McFarlane Aviation, LLC.
696 East 1700 Road
Baldwin City, KS 66006
(785) 594-2741 Fax: (785) 594-3922
www.mcfarlaneaviation.com
1-800-544-8594
sales@mcfarlaneaviation.com

Service Bulletin SB-12

December 12, 2023

I. SUBJECT

Figure 2: MC0513120 series Fuel Selector Valve w/ Outlet Fitting and O-ring

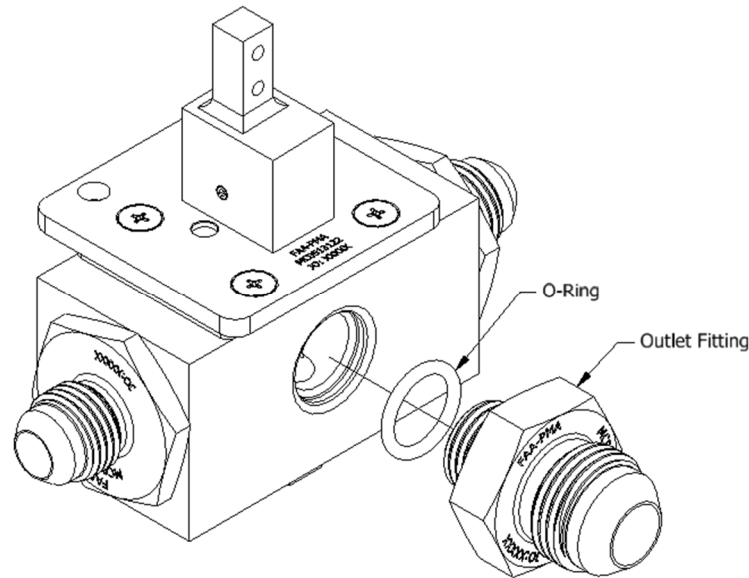
All fuel valves will require one (1) new outlet fitting and one (1) new outlet O-ring. (See Figure 2). These components are part of the relevant McFarlane service kit.

All repaired valves must use an MCM83248/2-906 O-ring for the outlet port. For the outlet fitting, use the table below to confirm the correct outlet fitting P/N for the repair of your Fuel Selector Valve:

Valve P/N	Outlet Fitting P/N	Service Kit
MC0513120-5	MC0513126	SB12-KT-1
MC0513120-6	MC0513126-1	SB12-KT-2
MC0513120-8	MC0513126-1	
MC0513120-9	MC0513126-1	
MC0513120-200	MC0513126-1

6. Slide new outlet O-ring around threaded end of the new fitting until making contact with the wrench flats.
7. Lubricate new outlet fitting threads with a thin coat of general purpose grease to prevent galling.

8. Thread new outlet fitting into the valve body and tighten until sealed (Torque fitting to 13-14 ft-lbs. or 156-168 in-lbs.)
9. Resecure drain plug to outlet fitting with .021", or larger, safety wire.
